ROAD STANDARDS VARIANCE REQUEST

TIGER & WILDCAT PLATS ROAD VARIANCE 08-29

TO: Mackenzie Moynihan, CDS
FROM: Christina Wollman, Planner II CW
DATE: June 19, 2008
SUBJECT: Tiger Plat LP-08-22
Wildcat Plat LP-08-24
Additional Information Requested

RV-08-27

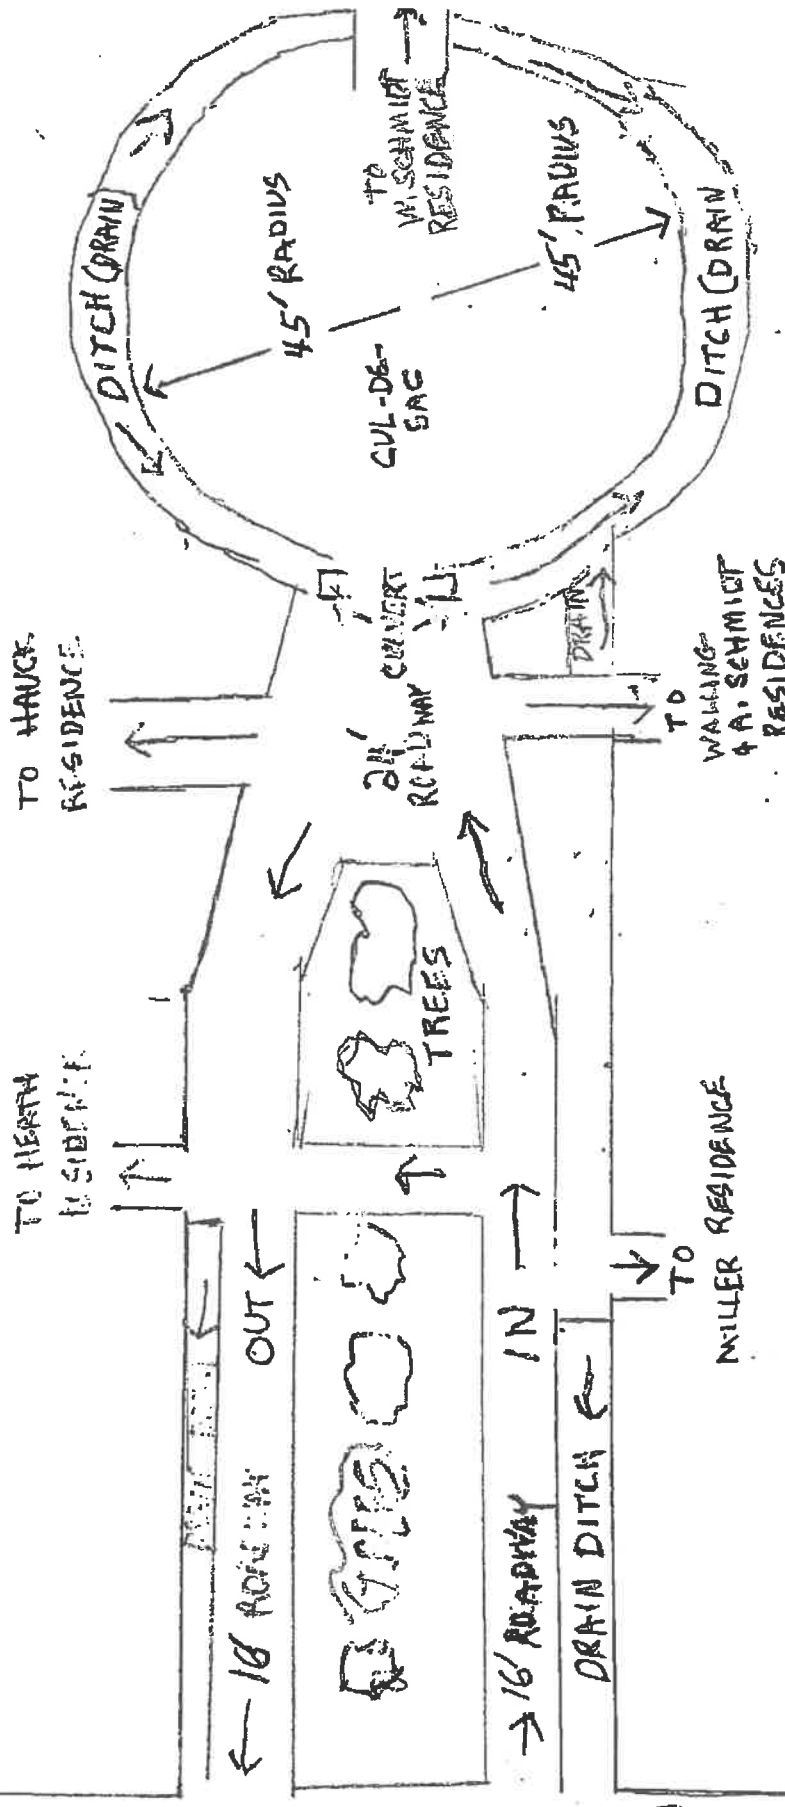
Request (be specific): A portion of Mission View Drive is constructed as 16' one-way roads for ingress and egress rather than the standard 24' roadway width. Request a variance to this standard to accommodate existing road extension to serve Tiger and Wildcat Plats.

Reason for request: A similar variance for Mission View Drive was approved earlier for Schmidt Short Plat (SP-96-14) and Eagles Landing Short Plat. This variance has worked well for over ten years and no reason is apparent that why it won't work as well for an extension of 1/4 mile to serve Tiger and Wildcat Plats.

Note: Lots G & H of Wildcat Plat will be accessed by a lane from a separate owner's property to the east. A land trade for an easement was accomplished and legally recorded.

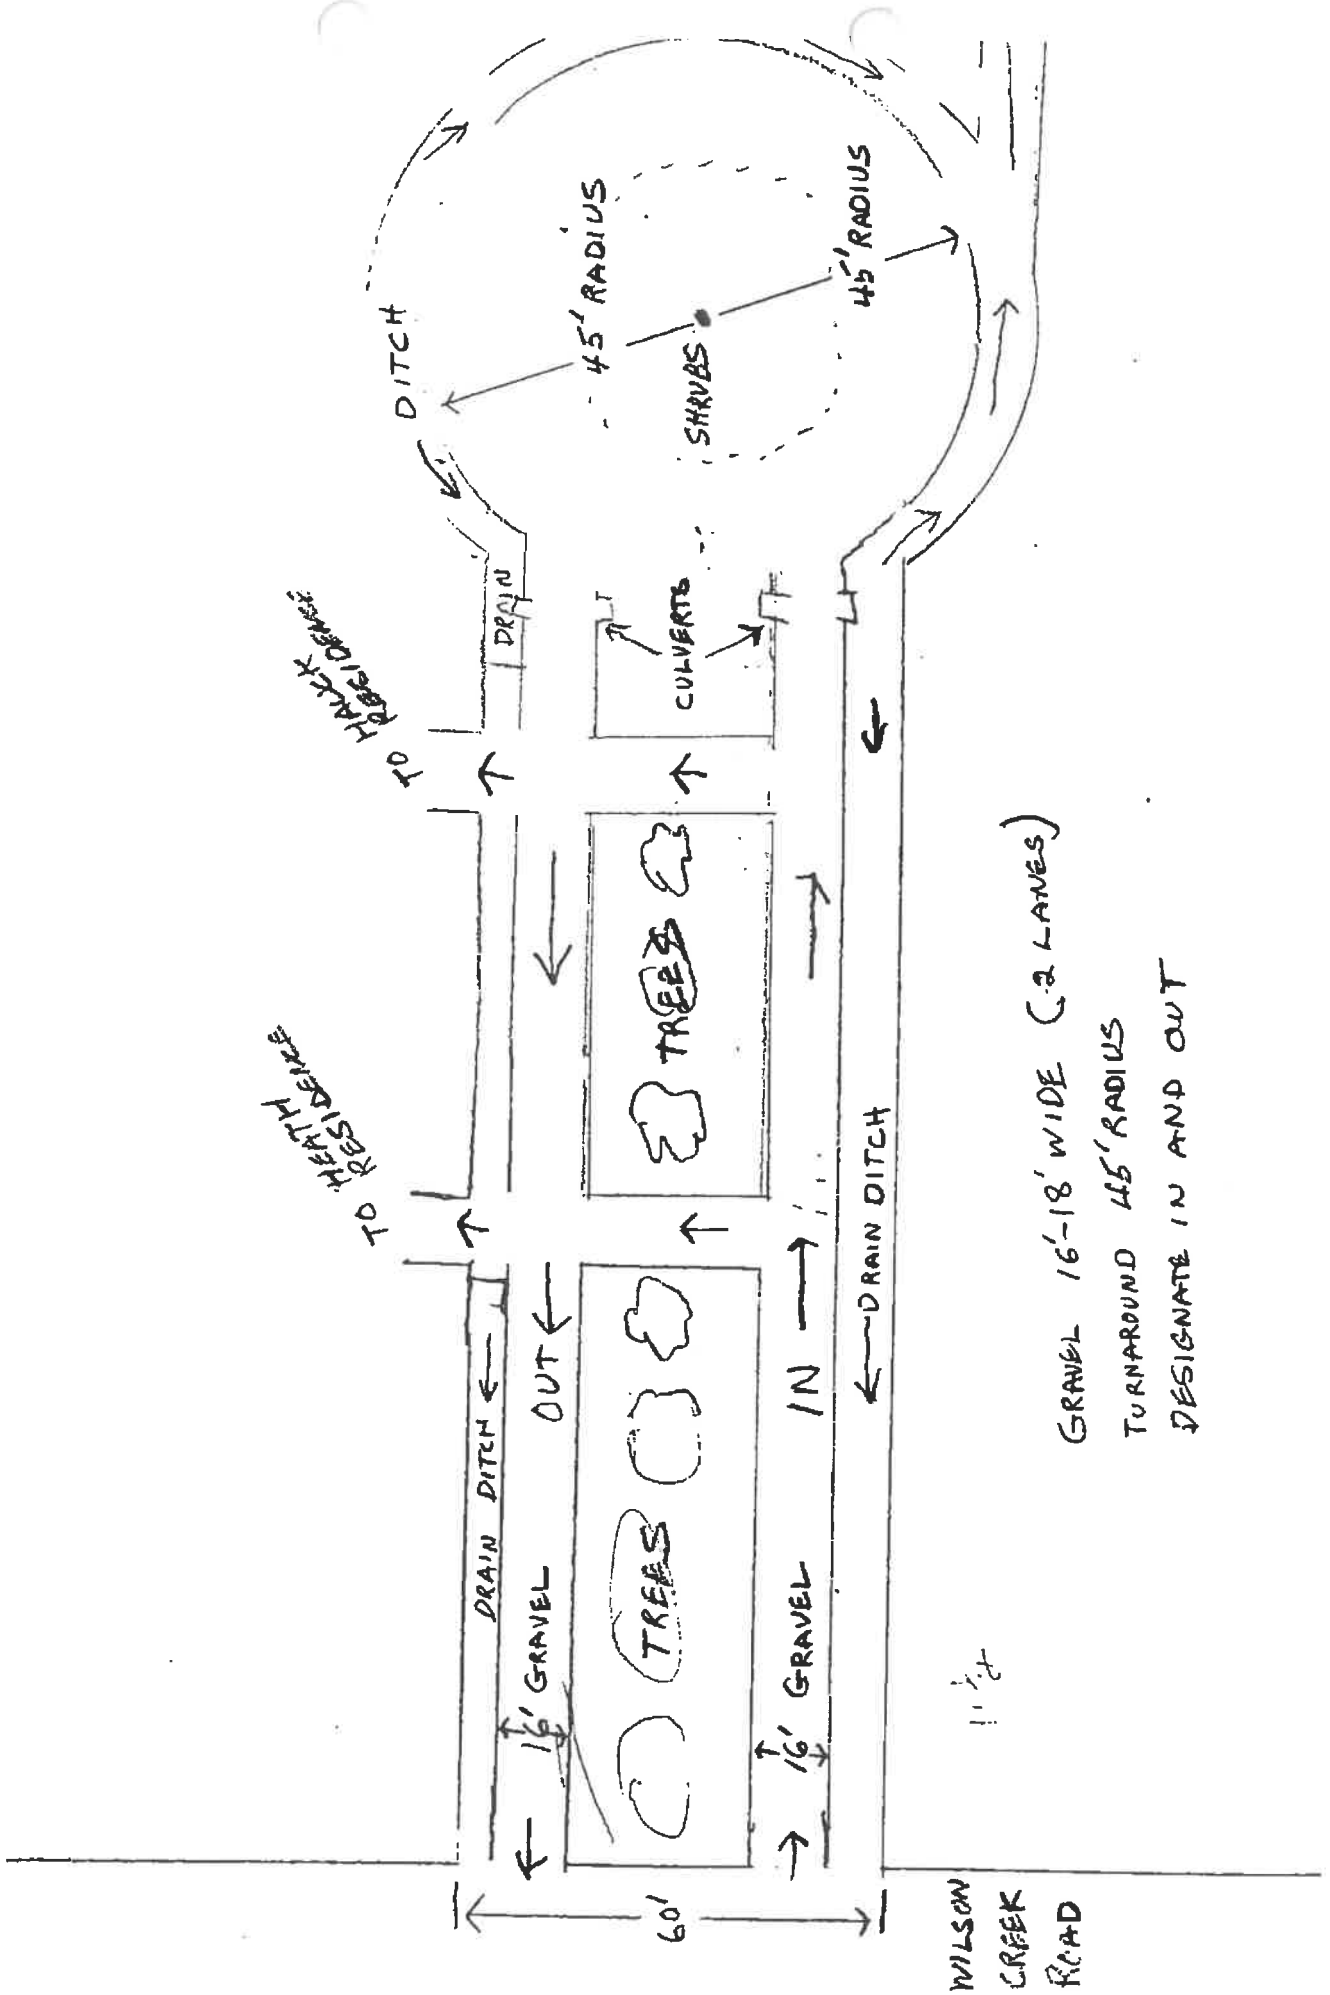
Proposed Access Plan: A one-way ingress road and a one-way egress road with a row of trees between the two roads.

1. Access to County Road: A single access location must be used at the point where the private road accesses onto Wilson Creek Road. The access shall be a maximum of 22' wide and a minimum of 15' in length or extend to the edge of the County Road Right of Way, after which, the private drive will split into two one-way 16' gravel surface roads.

2. Road width: Two 16' wide gravel surface roads would be acceptable for the one-way egress and one-way ingress road ways.
3. Maintenance of Trees: The row of trees between the two roads would need to be trimmed and maintained to a vertical clearance of 13' 6" the maintenance of the road and trees would be addressed in the road maintenance agreement.

4. Cul-de-sac: A 45' radius cul-de-sac will be required. Note: an equivalent or alternative configuration may be considered.
5. Well Location: Contact Holly Duncan at Kittitas County Environmental Health regarding the location of the proposed road and well location issues.

6. Signing: "One Way" and "Do Not Enter" signs must be installed. The signs will be the responsibility of the property owners. The maintenance of the signs will be addressed under the road maintenance agreement.

BOUNDARY OF TIGER PLAT
 BOUNDARY OF WILDCAT PLAT

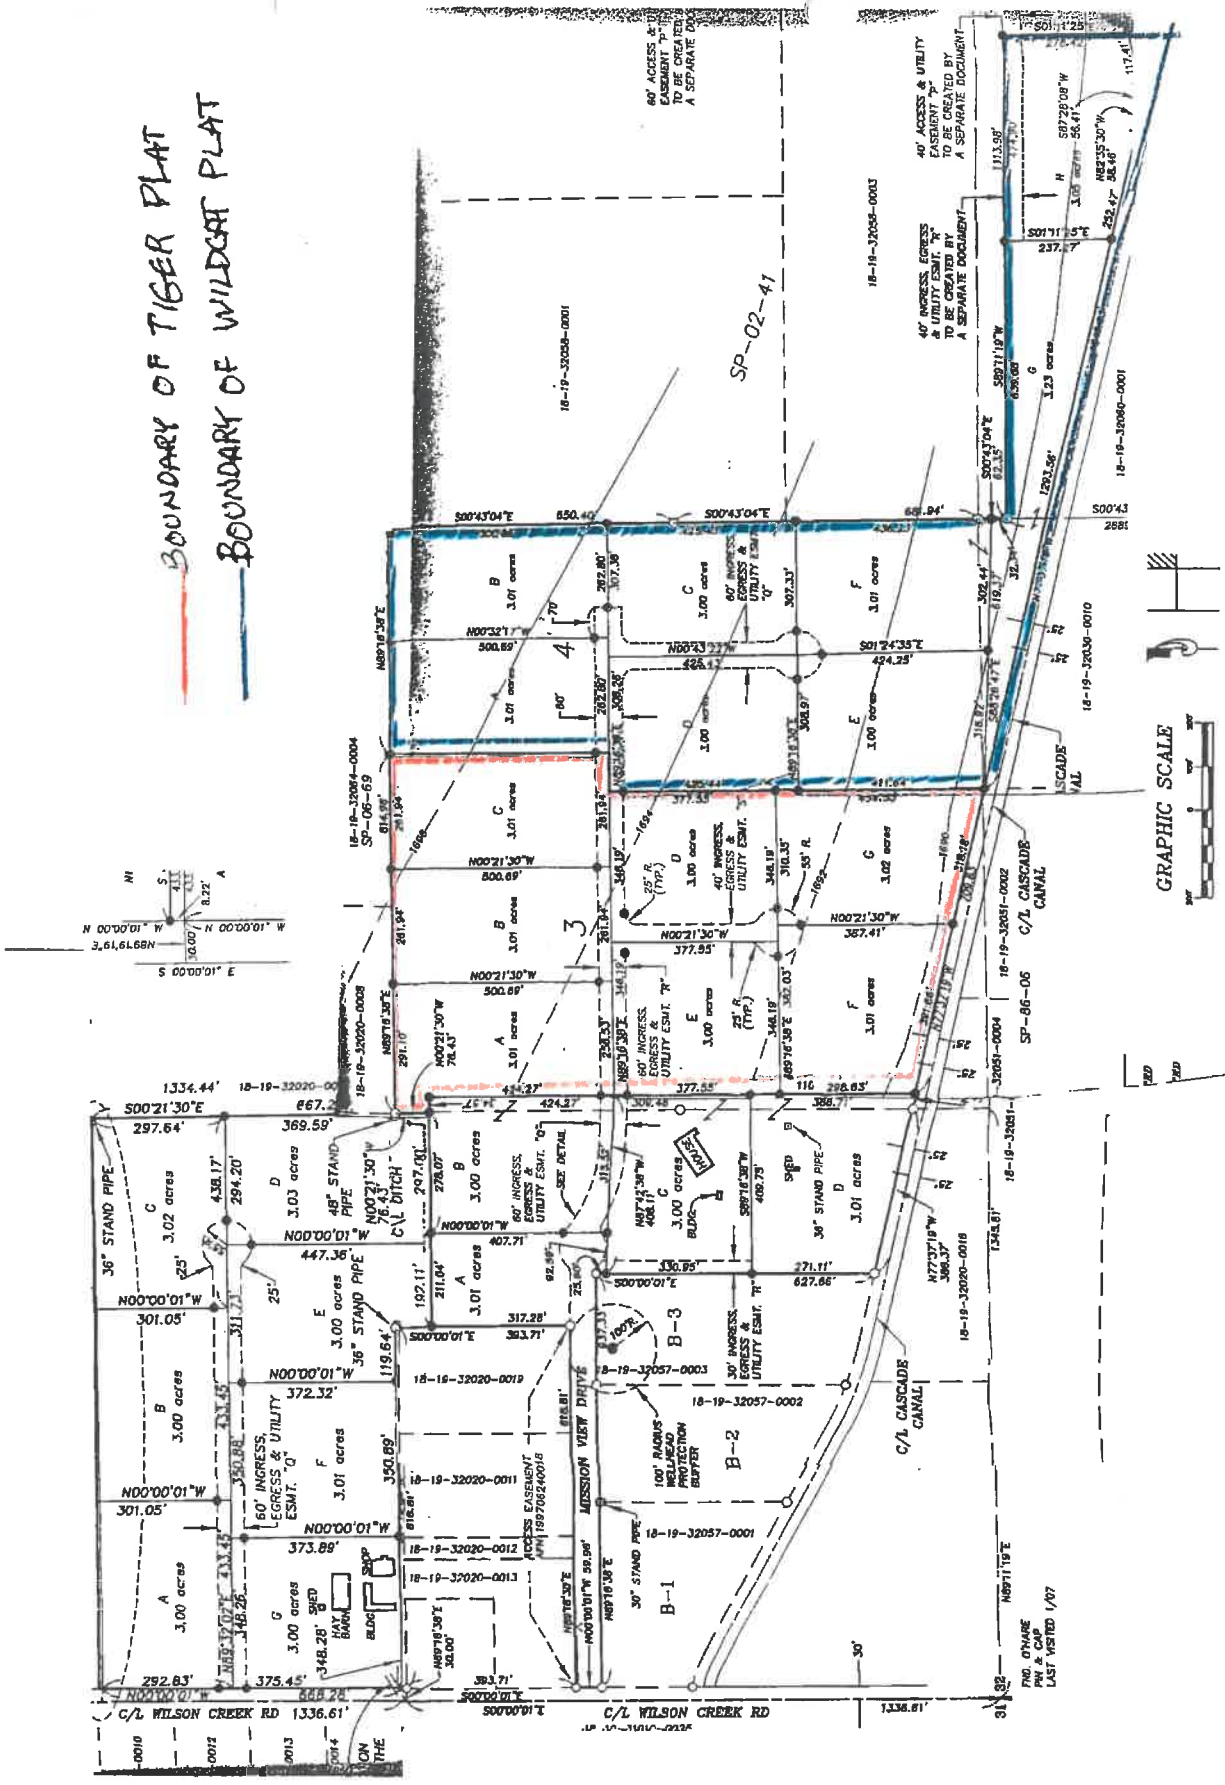
List of supporting documents attached: (1) A drawing of Mission View Drive, as it exists today. (2) Map showing Mission View Drive extension to accommodate Tiger and Wildcat Plats.
